**BHEL PSSR SCT DEPT
CHENNAI
Corrigendum-3,dt:3/6/2016**

BHEL's clarifications are furnished below against some of the bidder's query sought vide letters/email for the Tender Specification BHEL PSSR SCT 1615- NCTPS Stage-III - Main Plant Civil

SECTION 5-5

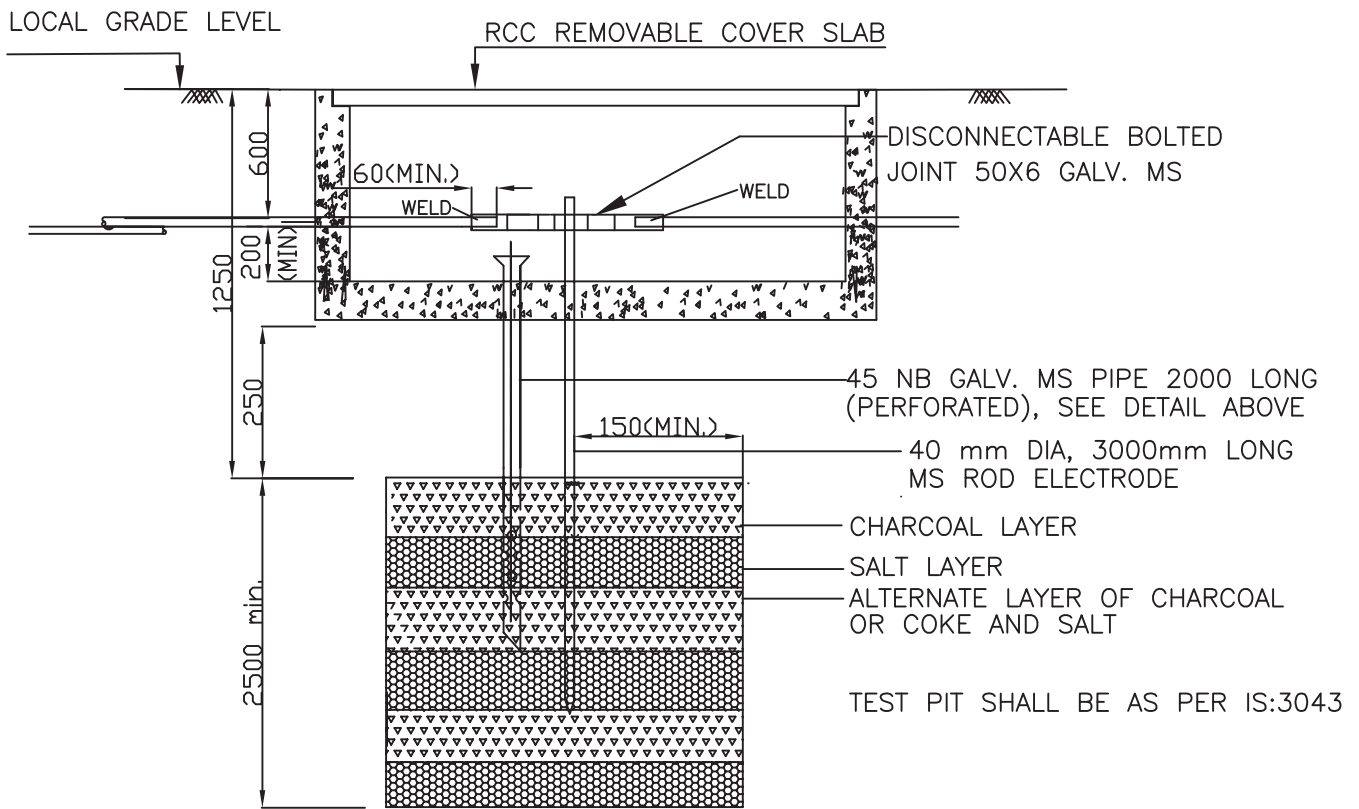
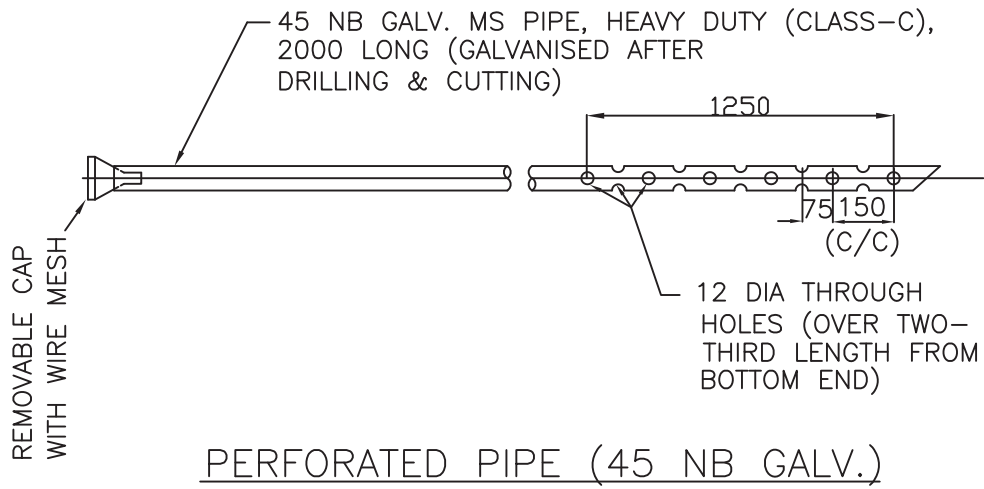
12	BOQ-A1609	Providing and Fixing acrylic solid surface (ASS) with 12mm thick ASS sheets of approved shades/color and duly cut on high precision CNC machines for decoration and aesthetic view purpose in plan or elevation including fittings, fixtures etc all complete as per specification	Please provide vendor & drawings for this item	1) Drawing will be provided during execution. 2) Bidder to explore in the market for the vendors
13	BOQ-1804	Supply and installation of approved 25mm thick vibration damping resilient pads on/around foundation of vibrating equipment and at other locations all complete.	Please provide vendor for this item	Bidder to explore in the market for the vendors
14	BOQ-A1813	Providing Earthing pit as per drawing with charcoal & salt, GI pipes, GI earth electrodes, GI wire, GI strips, brick chamber with covers including associated earthwork etc. all complete.(Material for GI pipes, GI earth electrodes, GI wire, GI strips shall be supplied by BHEL free of cost).	Please provide Earth pit Size	Typical Drawing is attached.
